SERVICE BULLETIN

APPLICABILITY: 2019-20MY Forester

NUMBER: 12-291-20

SUBJECT: Staining on Finish of Rear Gate Panel

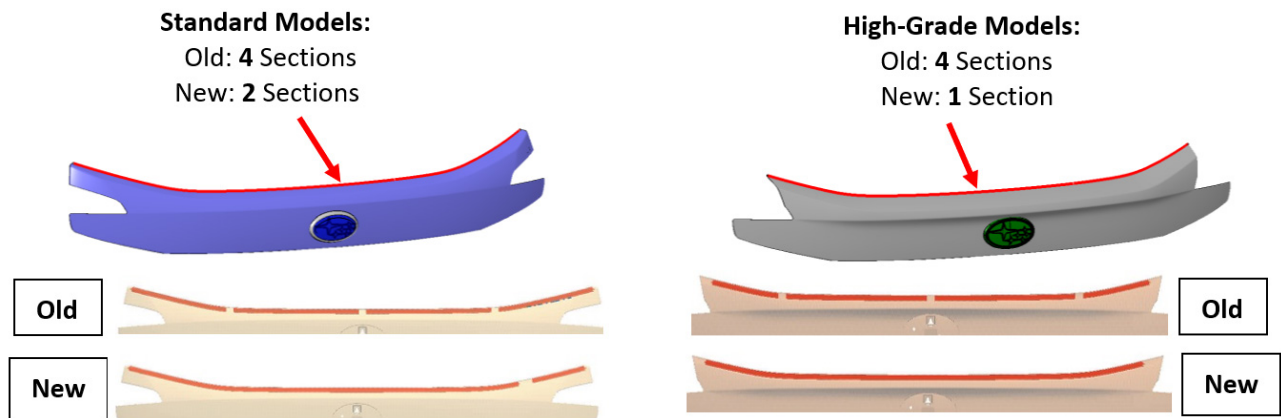
This bulletin announces a design change made to the rubber protector located between the top edge of the rear gate garnish and the glass. The change was made in response to a number of concerns regarding vertical brownish-colored stains appearing on the rear gate panel below the garnish and / or the license plate as shown below. Although hard to see in the photos, the callouts represent locations where the staining has been identified.

The staining is caused by an anti-hardening chemical used in the rear wiper blade insert. Over time, the chemical may be extracted from the insert by vehicle washing and rainwater. Carried by the runoff water, the chemical can drain through the gaps between the sections of the old-style rubber protector which may cause a stain to develop on the rear gate finish below the garnish. Depending on the vehicle trim level, new style protectors either eliminate or reduce the number of gaps from 4 to 2, redirecting the runoff water. Detailed illustrations are provided below in the Parts section.

In the illustrations below, the protector is shown as the red line along the top edge of the rear gate garnish.

STANDARD Models

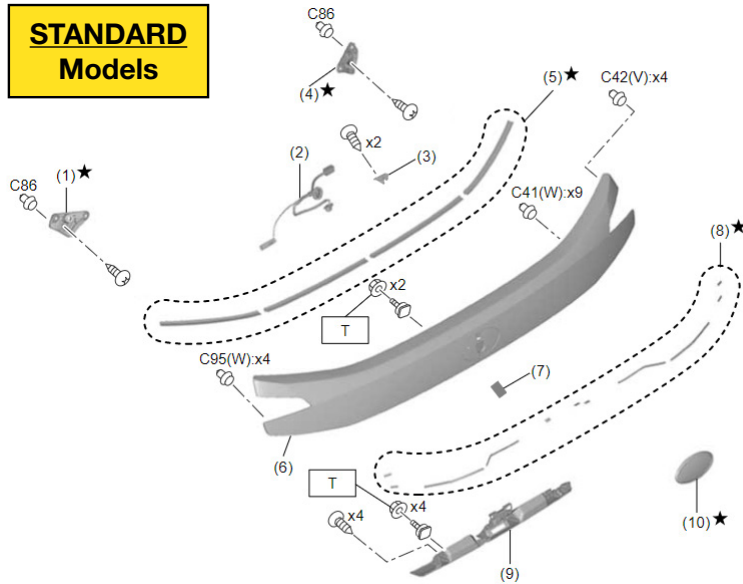
Both upper protectors described above (which replace #5 shown in the illustrations below) along with the multiple-piece lower protectors which are assembled along the bottom edge of the garnish (#8 below) and the left and right-hand garnish brackets (#1 and #4 below) are all **one-time use** items requiring replacement any time the rear gate garnish is removed. (The SUBARU emblem (#10) is also one-time use.) Garnish retaining clip reference is also provided below although, they are reusable as long as they are not damaged.
